Re: JacDan Building, 13432 Copper Avenue NE
Permanent Certificate of Occupancy – Transportation Development
Engineer's Stamp dated 05-21-10 (K22-D013)
Certification dated 04-05-11

Re: Jac-Dan Storage, 13432 Copper Ave NE, Traffic Circulation Layout
Engineer's Stamp dated 05-21-10 (K22-D013)

**Re: Jac-Dan Storage, 13432 Copper Ave NE, Traffic Circulation Layout
Engineer's Stamp dated 05-07-10 (K22-D013)**

RE: REVISED DRAINAGE PLAN FOR JACK DANIELS BUILDING (K22-D13) REVISION
DATED 4/28/98

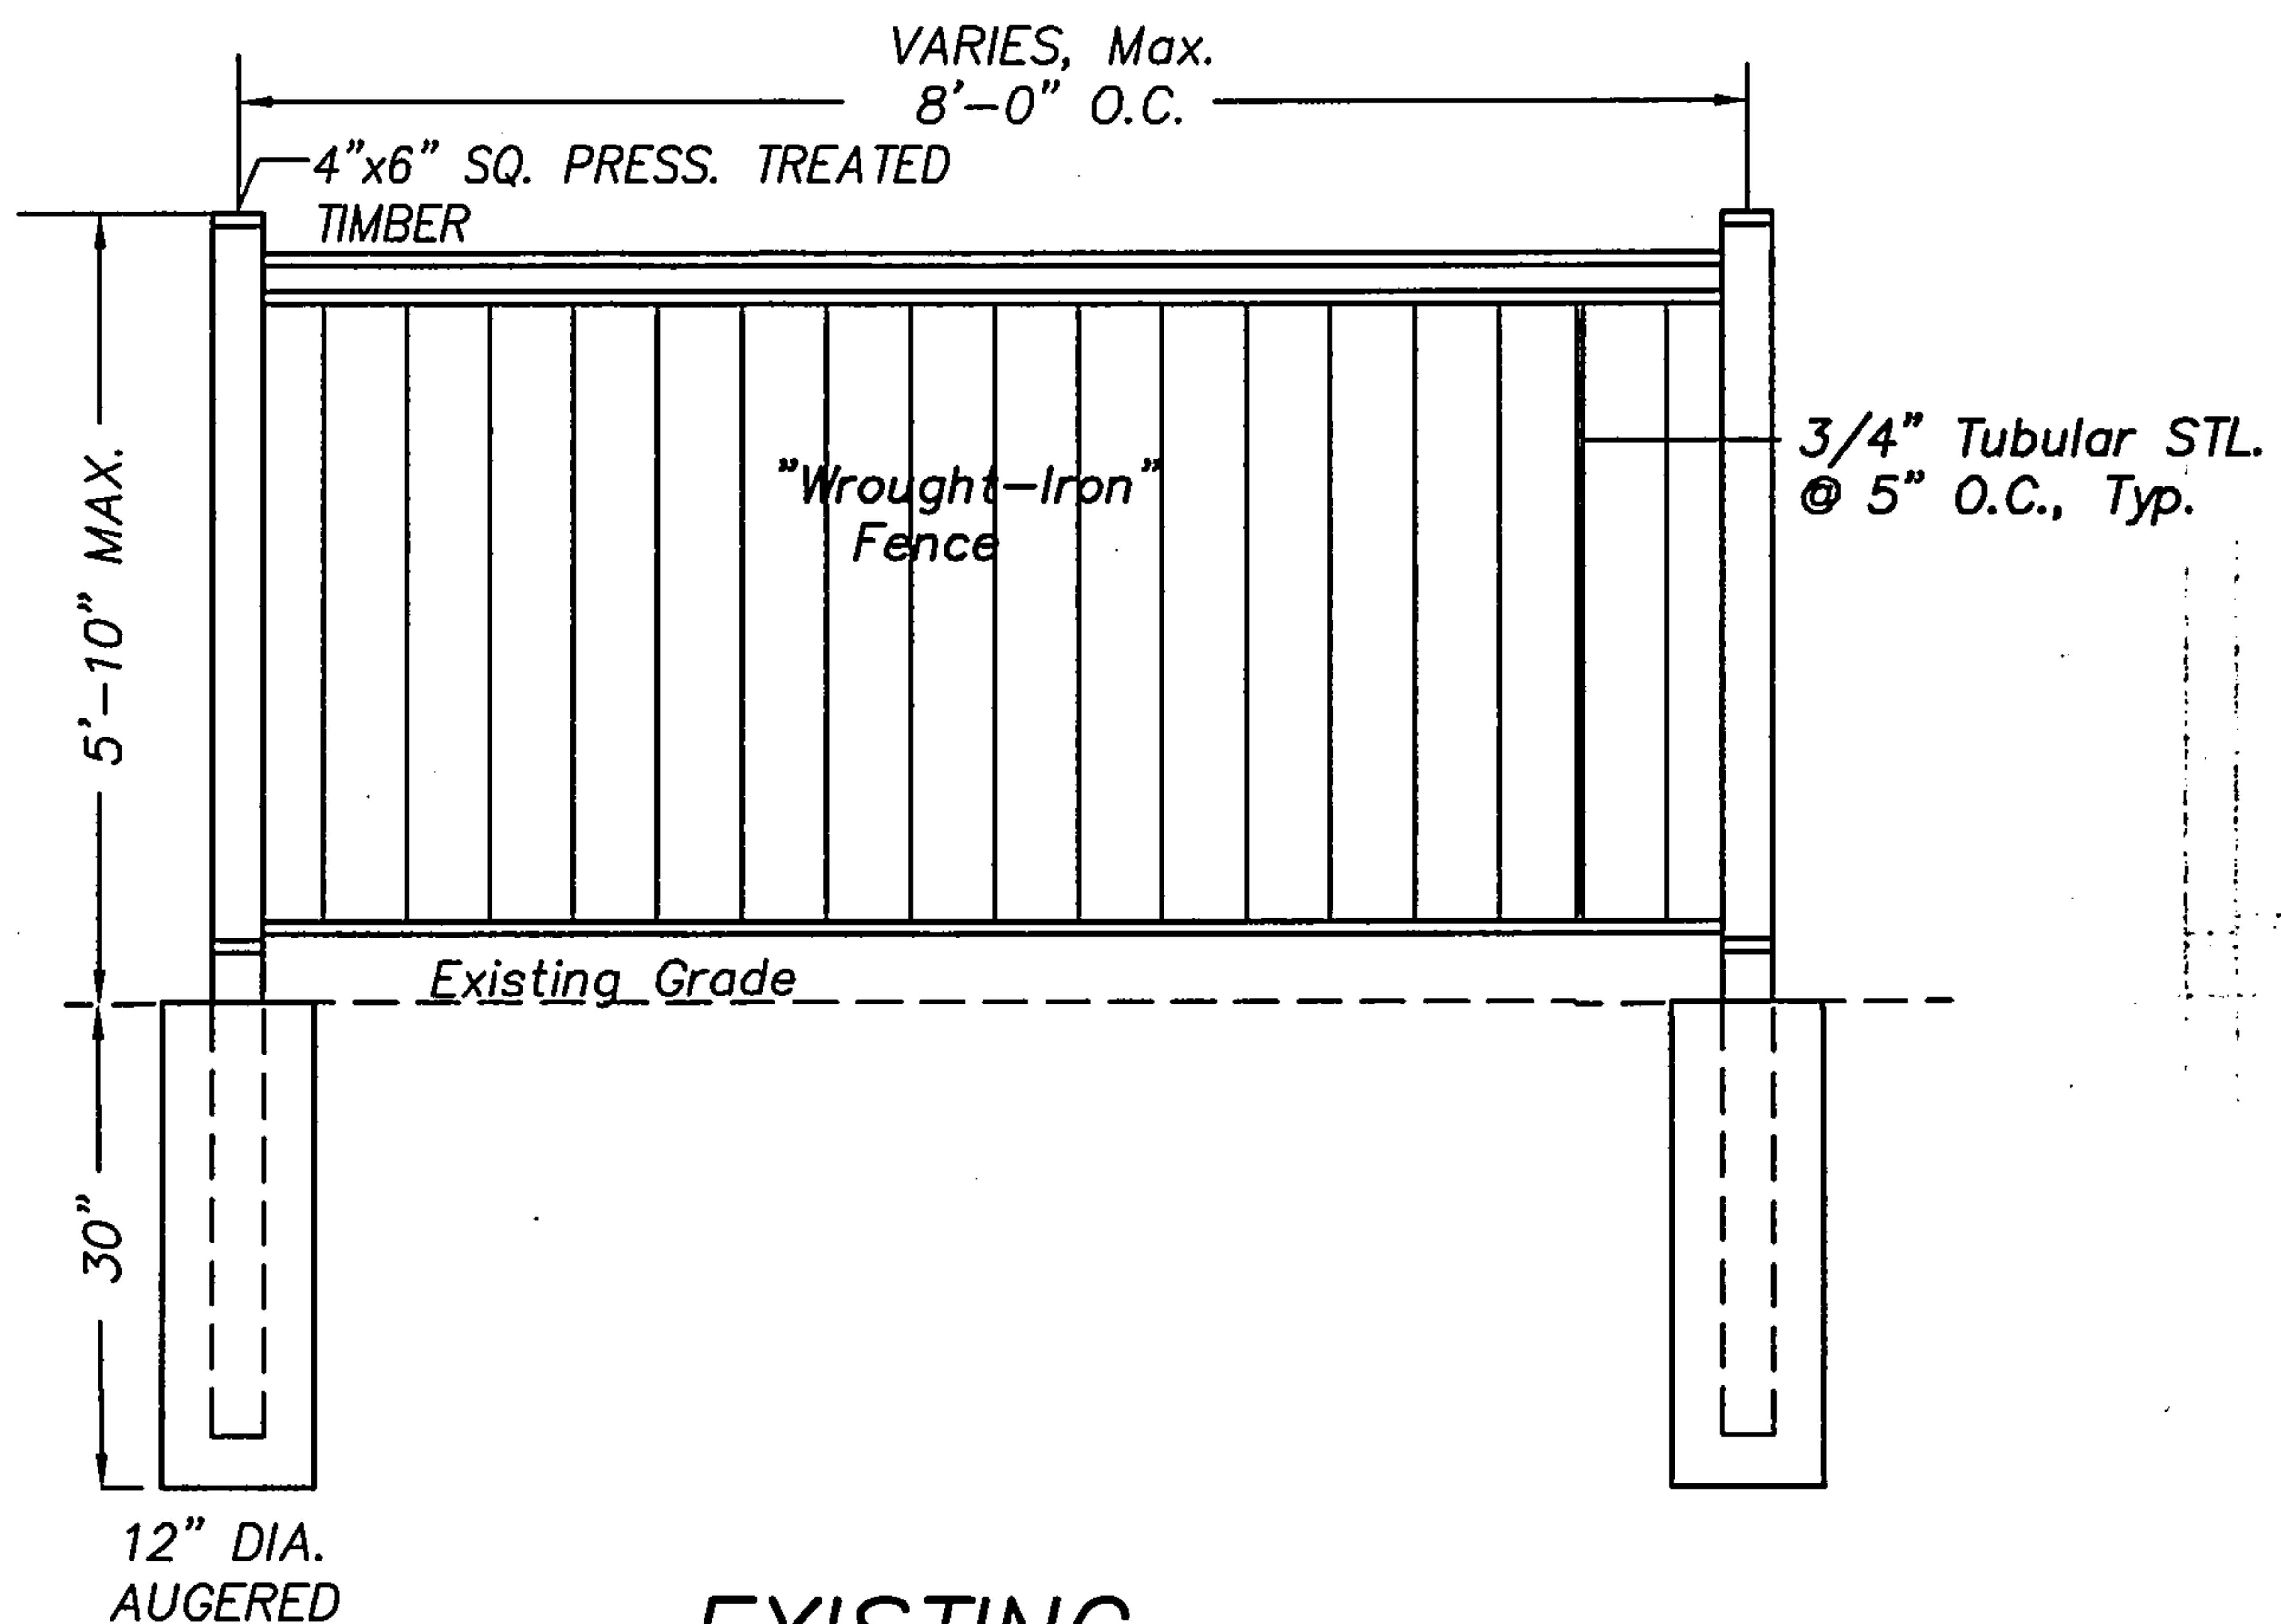
1. A 24-foot wide drive aisle is required for all two directional traffic. Please widen the 22.5-foot wide drive aisle to 24 feet.
2. Please list the width and length for all parking spaces.

3. Keyed note 1 should refer to CoA standard 2426, not 2440.
4. Clarify the ADA accessible pathway from the handicapped parking spaces to the building. Will a ramp be required? Please remove the concrete wheel stop in the van access aisle.

5. Include two copies of the traffic circulation layout at the next submittal.
6. Provide details for the existing iron fence. Will this fence interfere with the sight distance of the entrance? - in ROW, need encroachment agreement

7. Clarify the edge of existing asphalt in the northeast corner of the site.
8. A 6-foot wide, ADA accessible, pedestrian pathway is required from the right of way to the building.

comment 2: The widths are dimensioned in the string, the 20 foot length that is called out is intended as *typical*.

comment 3: I was referring to the access ramp itself here, specifically note 5 of 2440 - but will change to the private entrance st'd 2426. It seems that both dwgs could be referenced

comment: vertical iron bars @ 6" oc, open fence existing lending visibility - I've used this entrance personally and do not recall any issues. There are no solid pilasters. Do you have any further concerns?

comment 8: Can the 6' width be included within the 24' driveway throat?

comment 9: Is the truncated dome indicated in the legend not adequate?....that was the intent to build/install them + keyed note 1 was to ensure ADA compliance of the ramp, ie ensure 50:1, 3' wide level/landing area....etc.
